# 55 Cumberland Terrace 2021/1393/P

Delegated Re	port	NI/A			Expiry Date:	07/0	6/2021	
(Members Briefin					Consultation Expiry Date:	04/0	7/2021	
Officer					ication Numbe	er(s)		
Patrick Marfleet				2021/1393/P 2021/1766/L				
Application Address				Drawing Numbers				
55 Cumberland Terrace London NW1 4HJ				Please refer to draft decision notice				
PO 3/4 Area T	rea Team Signature C&UD			Authorised Officer Signature				
Proposal(s)								
<ul> <li>i) Conversion of 55 Cumberland Terrace and 29 Cumberland Terrace Mews into single family dwelling (Class C3) with associated external alterations including installation of air-handling plant at roof level and enlargement of link extension to the rear.</li> <li>ii) Conversion of 55 Cumberland Terrace and 29 Cumberland Terrace Mews into single family dwelling (Class C3) with associated internal and external alterations including installation of</li> </ul>								
air-handling plant at roof level.  Recommendation(s): Grant conditional planning permission and listed building consent							sent

## Site photographs

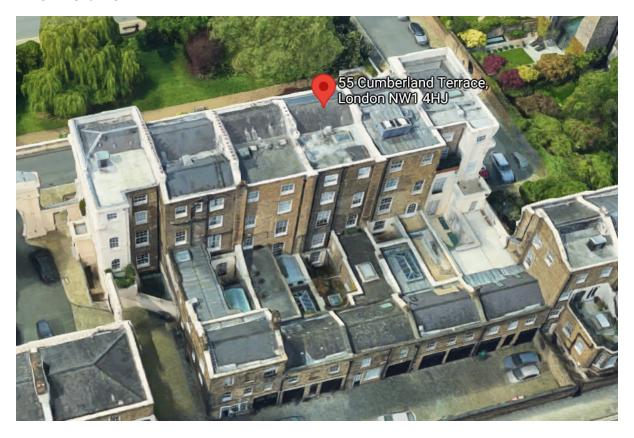
- 2.3.6 The current proposals seek to widen the ground floor rear link extension at the site to the depth of the existing staircase enclosure to the mews building (see images below). This widening of the extension is considered to represent a minor alteration that would retain the historic relationship between the principal dwelling (No.55) and mews building to the rear. Furthermore, officers note the prevalence of similar sized or larger link extensions to neighbouring properties in the terrace. As such, the proposed extension is not considered to cause harm to the appearance or special historic interest of the host building, wider terrace and surrounding conservation area.
